MADISON PARK MULTIFAMILY

MASTER USE PERMIT
DESIGN RECOMMENDATION PACKAGE -
ADMINISTRATIVE DESIGN REVIEW

SEATTLE DCI PROJECT #: 3038537-LU (3024825-EG)
06/30/22

EDG ITEMIZED RESPONSE

EAST ELEVATION

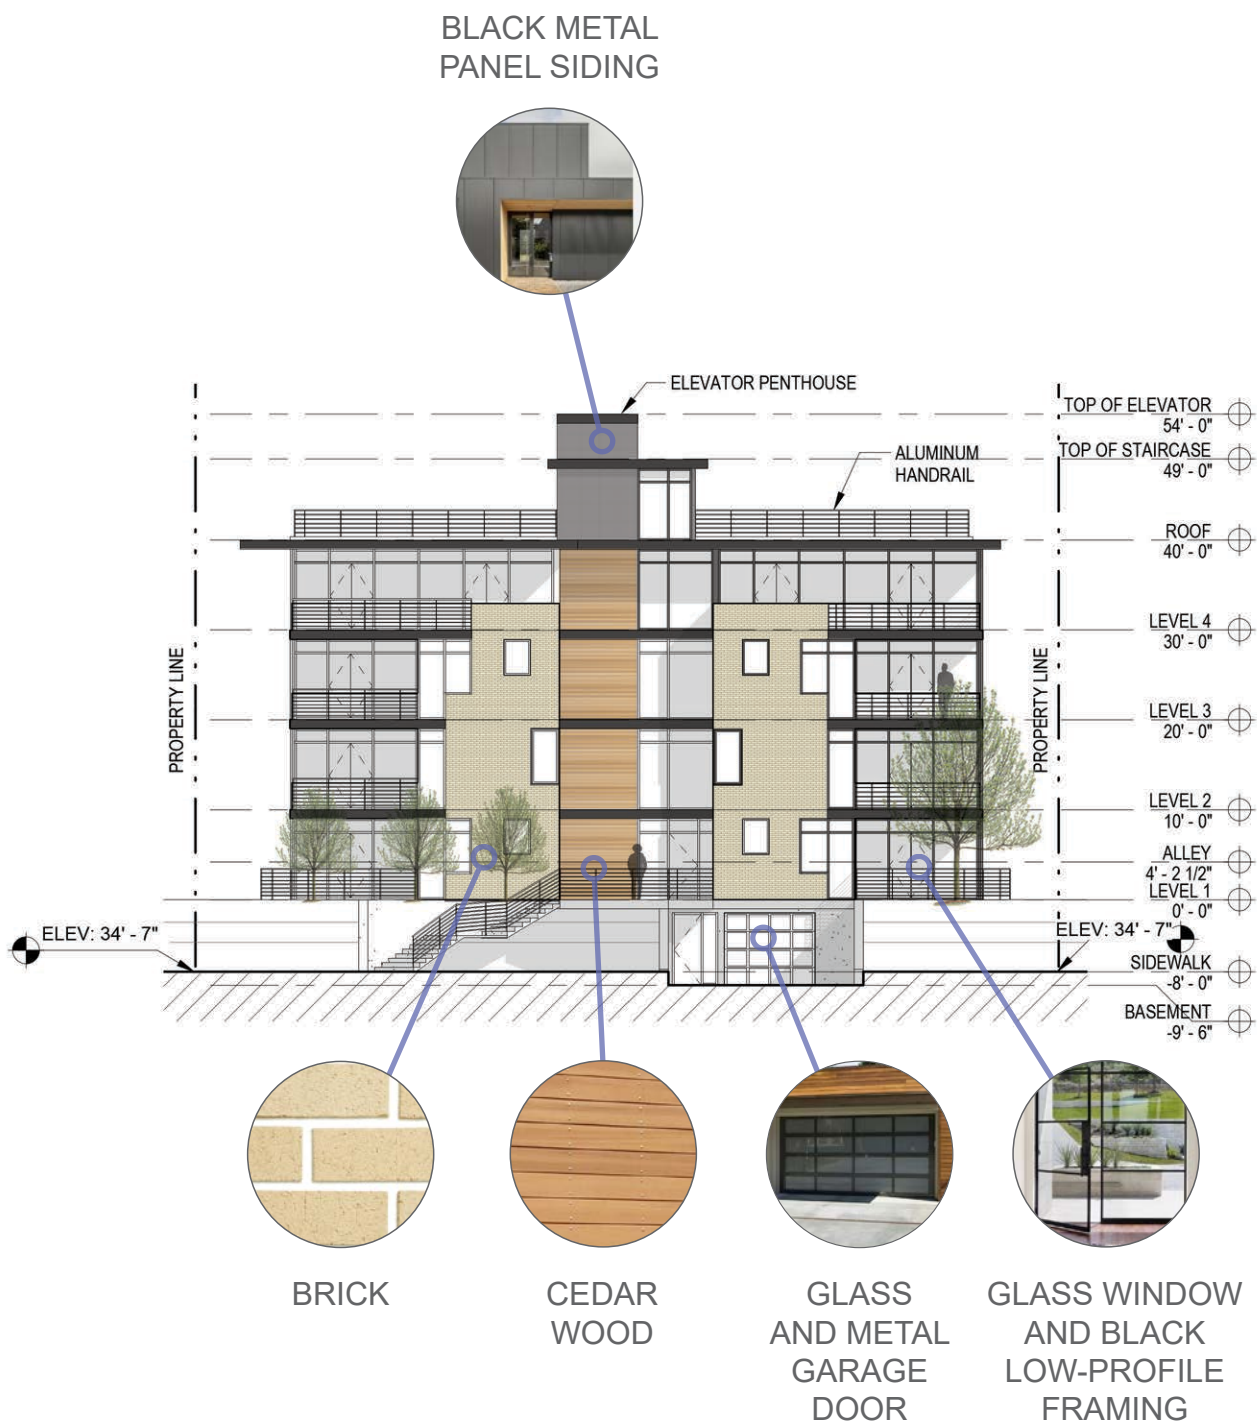
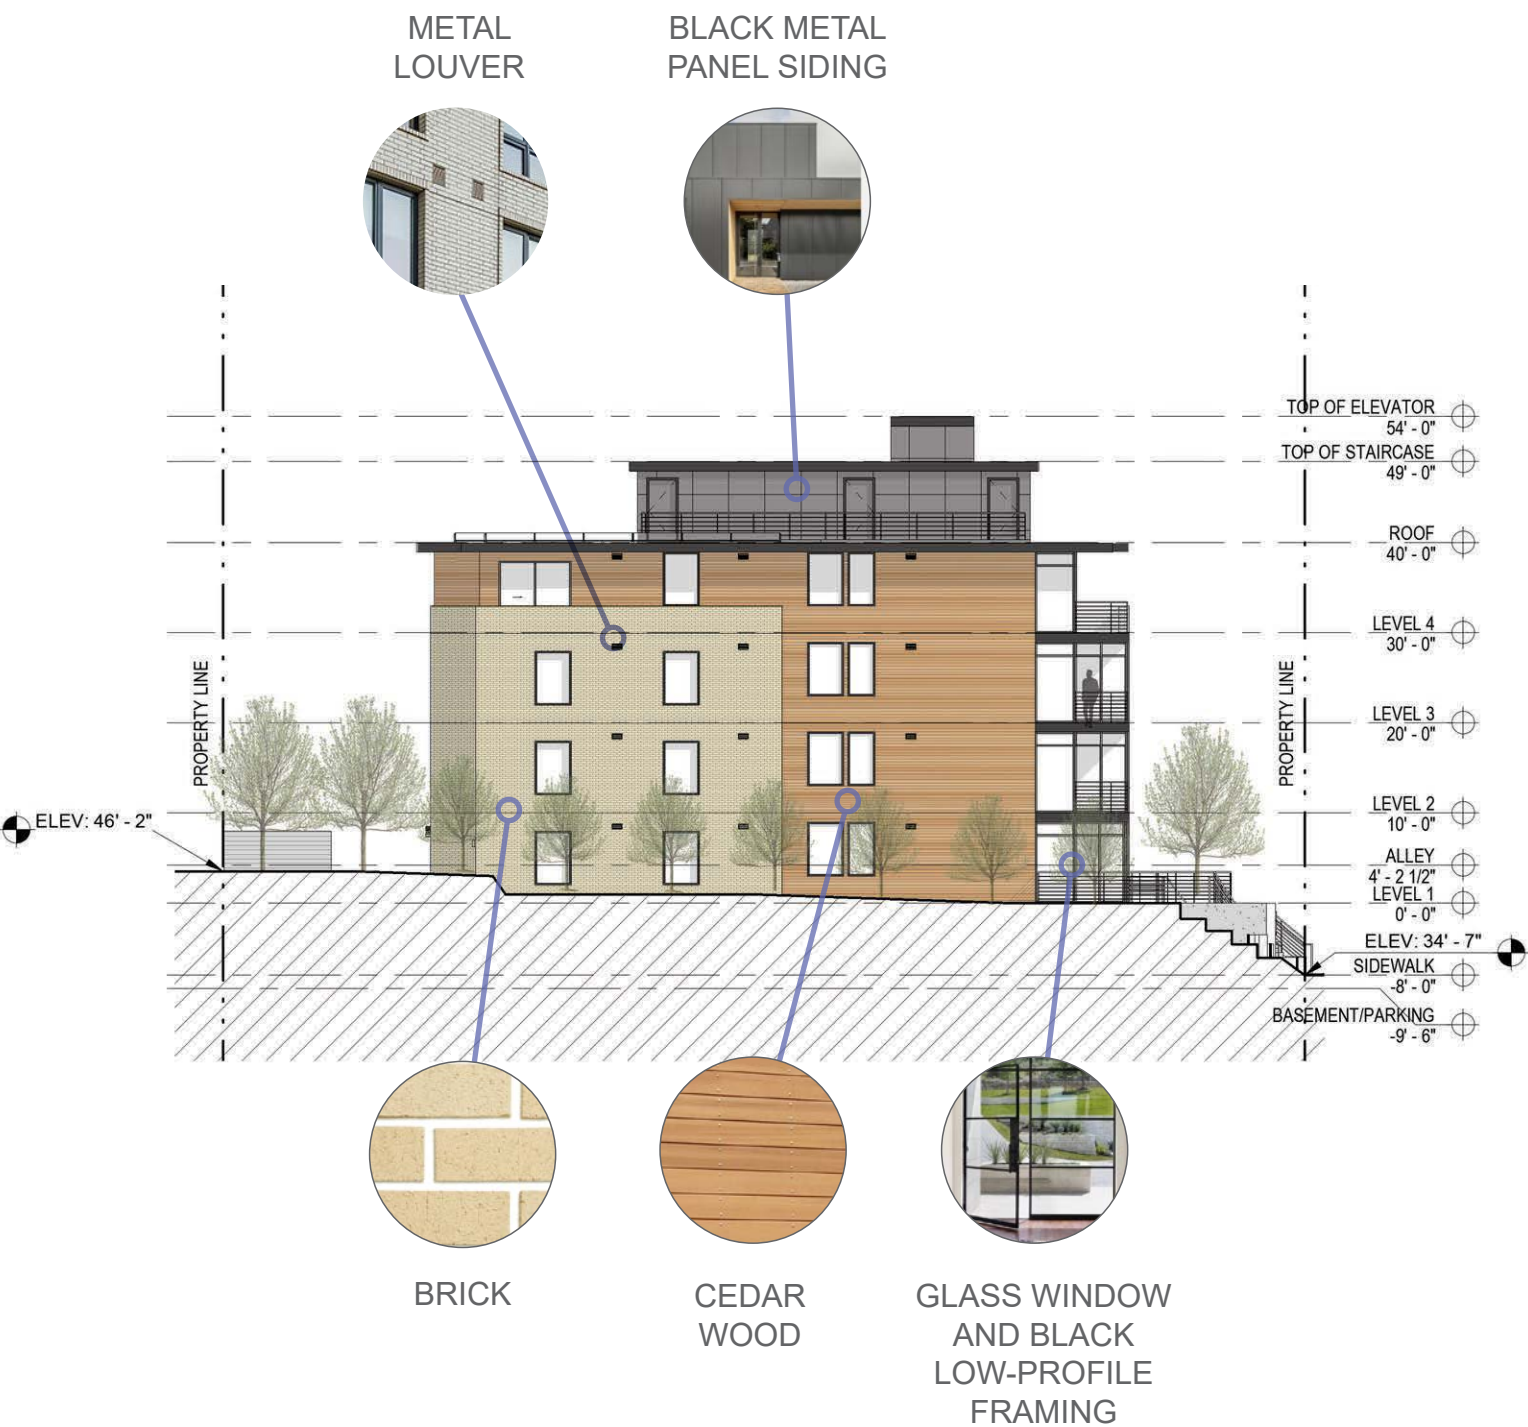
D. Staff requests additional elevation and section drawings that better demonstrates the relationship of the lobby entry, the elevation change and the street edge. (CS21, CS2-D, DC2-A-1, DC2-A-2, DC2-D, DC2-E)

Updated elevation and section drawings have been added that better demonstrates the relationship of the lobby entry, the elevation change, the street edge, and the parking entrance. From the public realm, the pedestrian entry pushes into the property with an inviting landing space with seating provided. The parking level entry is an accessible and intimate entry, recessed from the street edge and allowing for landscape screening and a green wall to create a softer edge at this level. The curving stair entry leading up the the semi-public terrace space directly off the main entry creates movement through the site, vista opportunities to the west, and amenity area for residents and visitors to interact. Refer to page 51-53 for more information.
